APPEAL SUMMARY

Appeal ID: 20218	Project Address: 1477 NE Alberta Street
Hearing Date: 4/10/19	Appellant Name: Ben Anderson
Case No.: B-016	Appellant Phone: 5039697736
Appeal Type: Building	Plans Examiner/Inspector: Jed Stoken
Project Type: commercial	Stories: 4 Occupancy: R2 & M or A-3 Construction Type: V-A
Building/Business Name: Alberta/Bezel	Fire Sprinklers: Yes - Throughout
Appeal Involves: Erection of a new structure	LUR or Permit Application No.: 17-197095-CO
Plan Submitted Option: pdf [File 1] [File 2] [File 3] [File 4] [File 5] [File 6]	Proposed use: commercial cal

Appeal item 1

**SUBJECT: RESPONSE TO BDS CHECKSHEET DATED MARCH 19, 2019
ALBERTA APARTMENTS
1477 NE ALBERTA STREET
PORTLAND, OREGON 97211**

EXHIBIT 1 - FOUNDATION PLAN

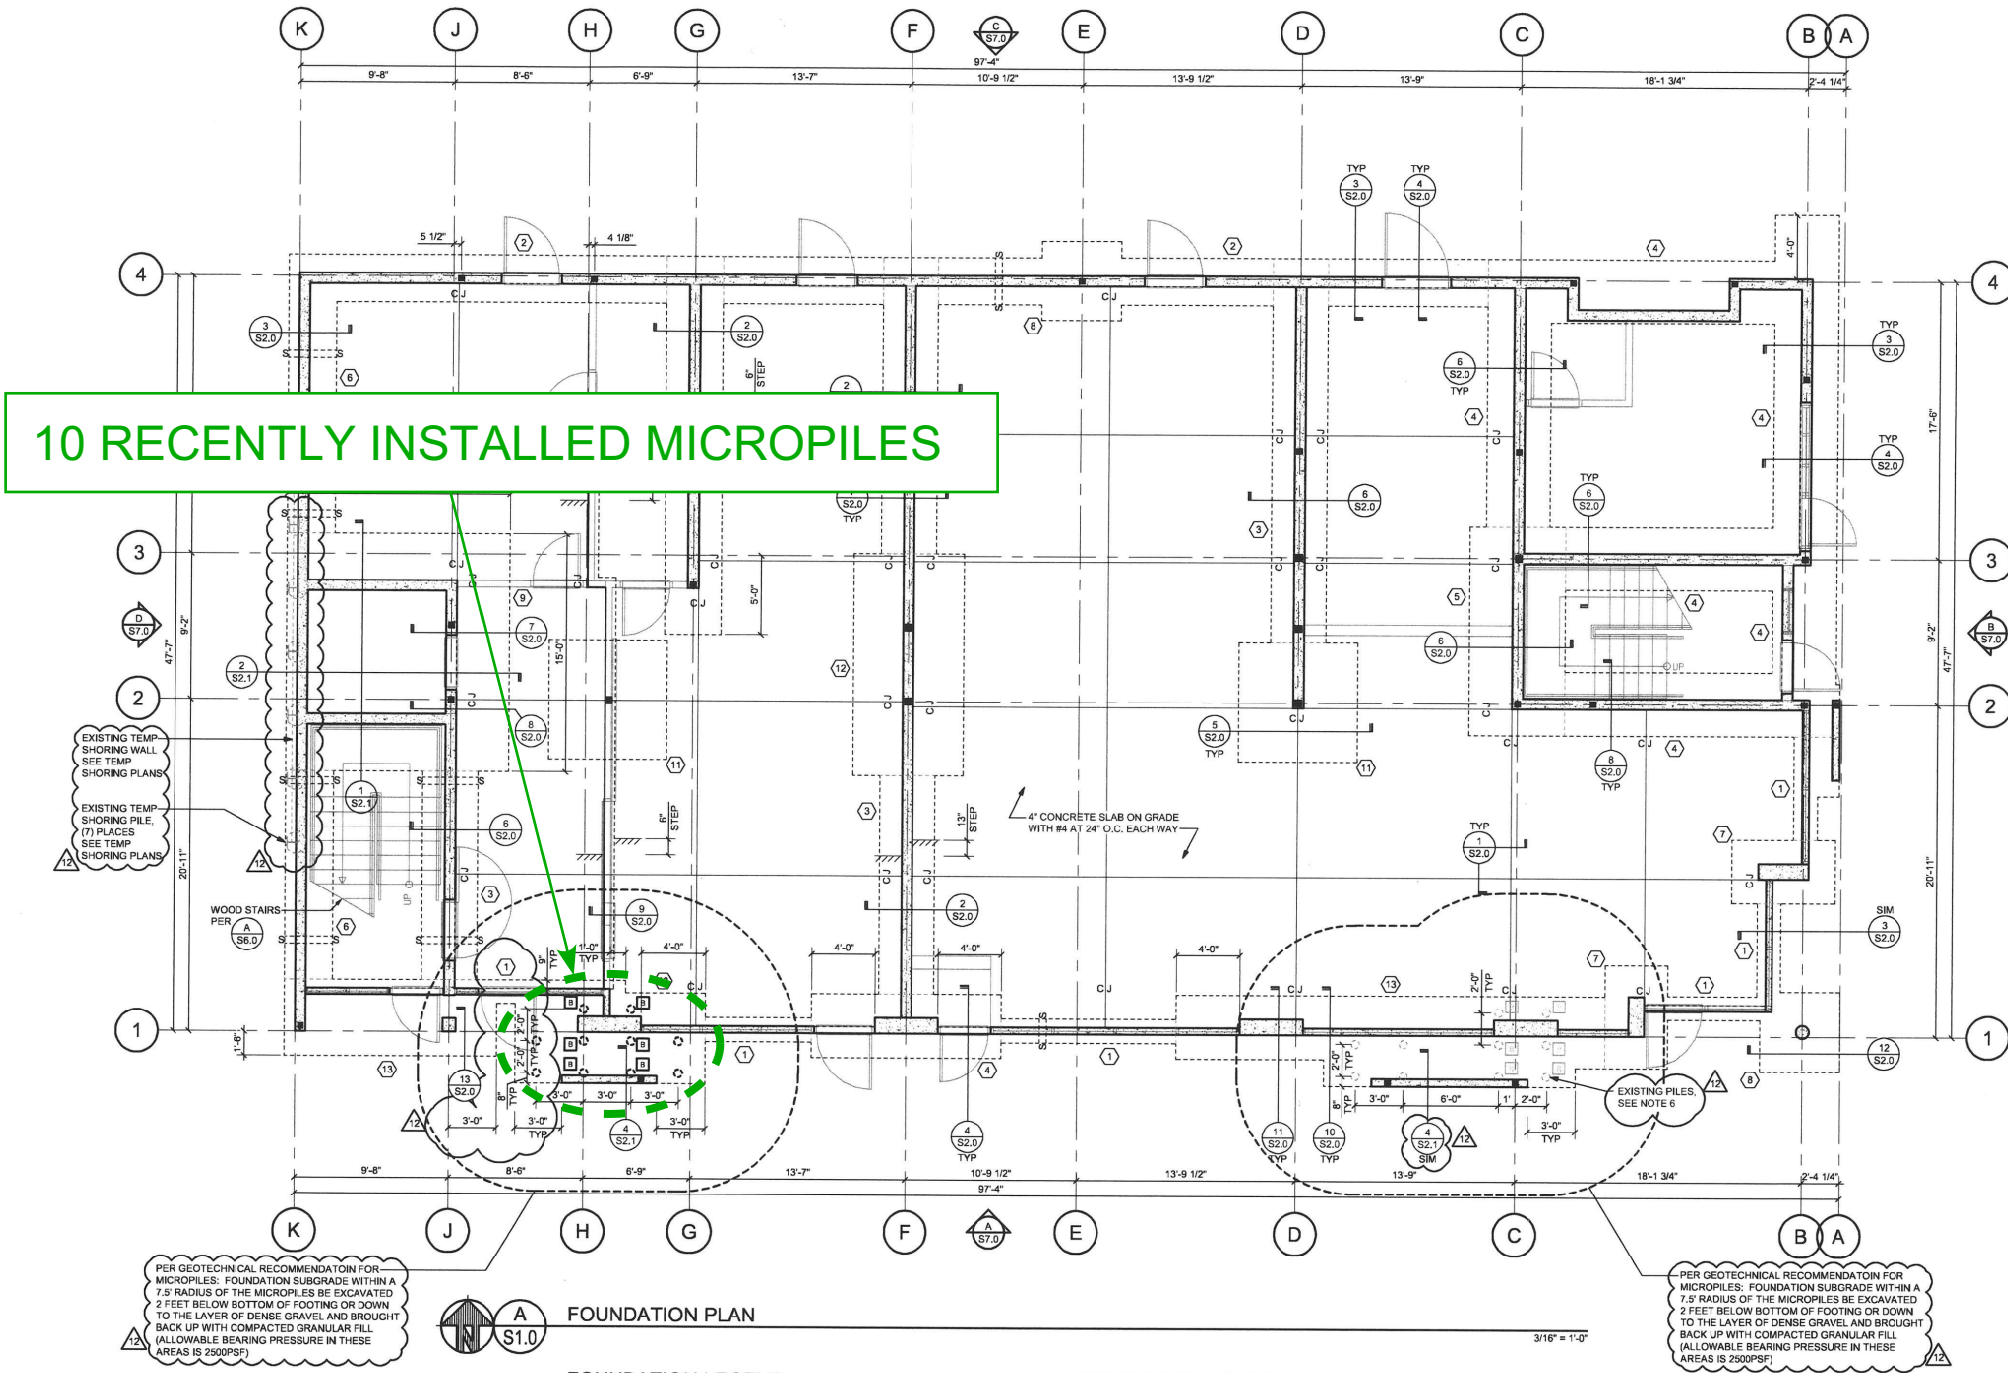
In the extremely unlikely event that the as-built micropiles were to fail due to excessive lateral displacement of the concrete footing at gridlines G.2-J.5/1, the concrete footing would remain supported by native medium dense sand and very dense gravel with a layer of compacted base rock at the ground surface. Even if the concrete footing were to no longer receive any support from the micropiles, we calculate that the vertical settlement of the concrete footing would be less than 1 inch, which would be compatible with the settlement of adjacent footings. The vertical settlement of the concrete footing would not cause significant damage to the building and would not pose a life-safety risk. Our calculation of vertical settlement for this hypothetical case is presented on Exhibit 6.

Use of existing micropiles: Granted as proposed.

EXHIBIT 2 - MICROPILE DETAIL

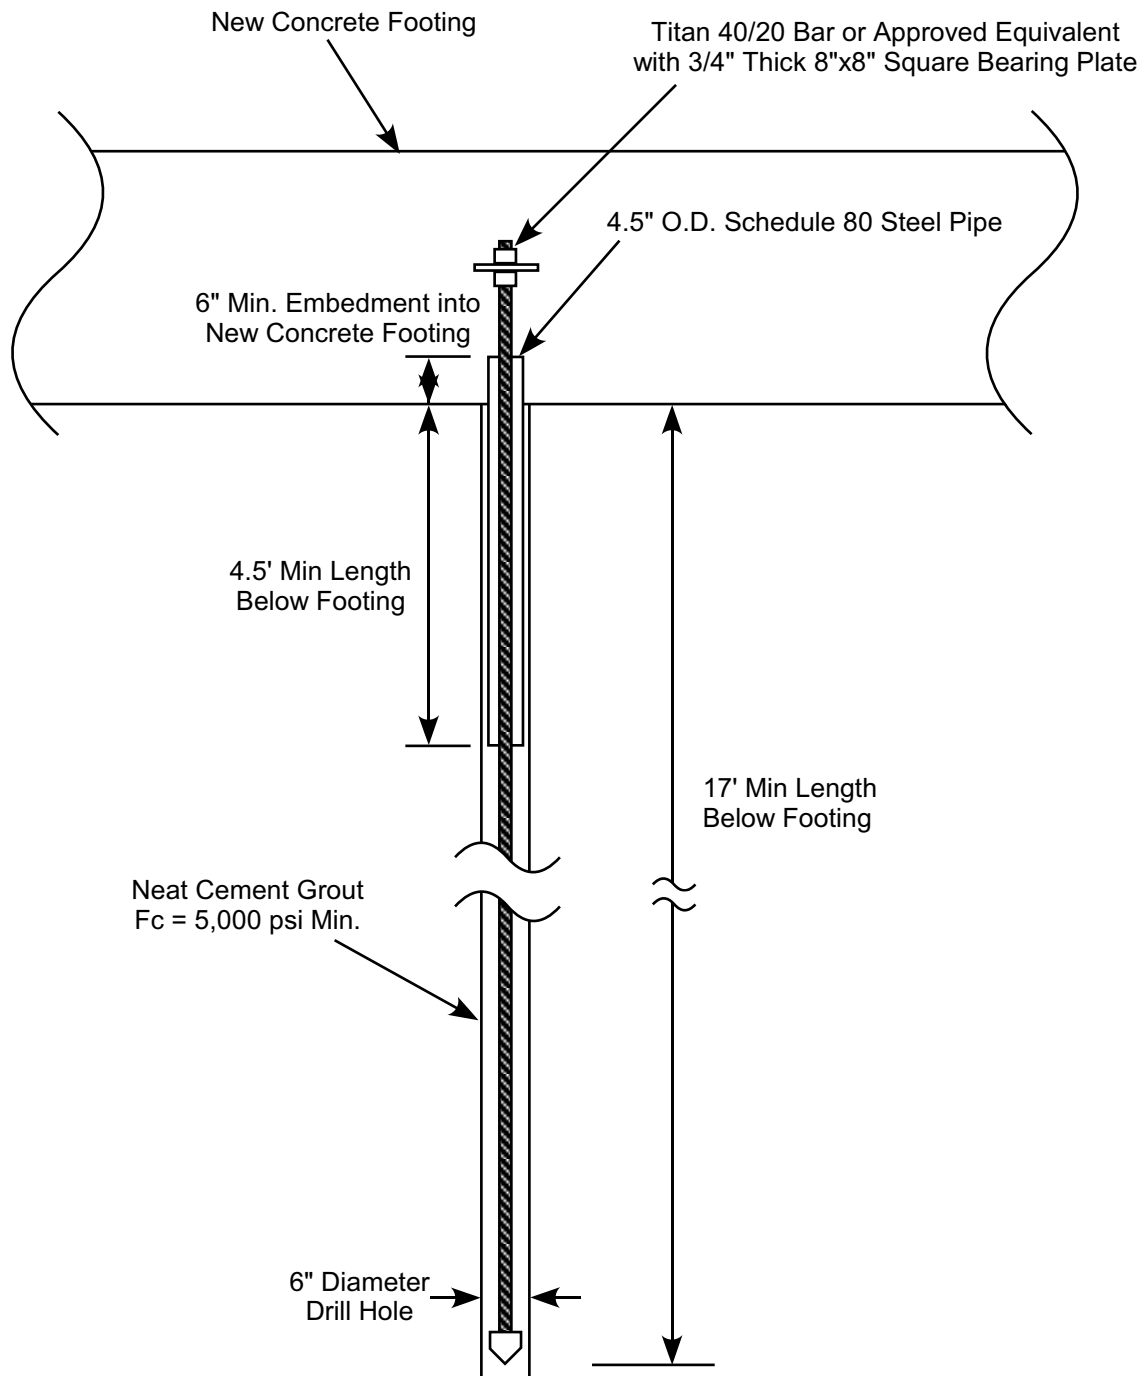
Checksheet Item #4 – Micropile Foundation

In response to Checksheet Item #4, we have provided a detail drawing to the design team, which is to be included in the drawing set. The detail drawing shows the center bar, casing, hole diameter, casing length, and overall length. A copy of the detail drawing is attached to this report.

Figure 1 – Free-Head Condition - Bending Moments in Micropile Due to 0.10 Inches Deflection

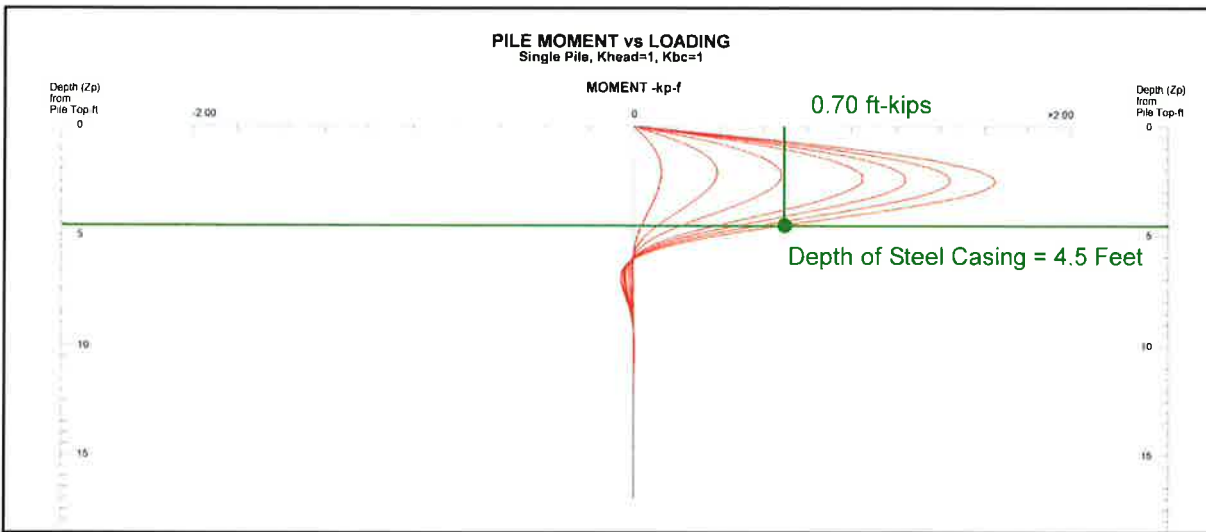
However, the city has expressed concern that some movement of the footing may occur before sliding resistance is engaged and has asked us to show that the steel casing extends down to the point of zero curvature. In response to this item, we conservatively assumed a deflection of 0.10 inches of deflection at the top of the micropile and evaluated the induced moments due to this deflection. Theoretically, the deflection required to mobilize sliding friction is near zero, but we conservatively assume a deflection of 0.10 inches for analytical purposes.

The steel casing installed in the micropiles extends at least 4.5 feet below the bottom-of-footing. Since the steel casing is to be embedded only 6 inches into the concrete footing, we assumed a free head connection. With an assumed deflection of 0.10 inches at the top of the pile, the bending moment in the micropile at the bottom of the steel casing is 0.70 ft-kips, as shown on the figure below.

Based on this analysis, the casing does not extend to the point of zero curvature, but the magnitude of the bending moment below the casing is very small. The calculated cracking moment of the micropile grout body is at least 0.84 ft-kips. Calculations for the cracking moment are attached to this report. Since the bending moment in the grout column below the steel casing is less than 0.84 ft-kips, the bending moments below the steel casing induced by 0.10 inches of deflection will not induce a crack the micropile. It is therefore our opinion that the micropile can withstand 0.10 inches of deflection and still perform as designed.
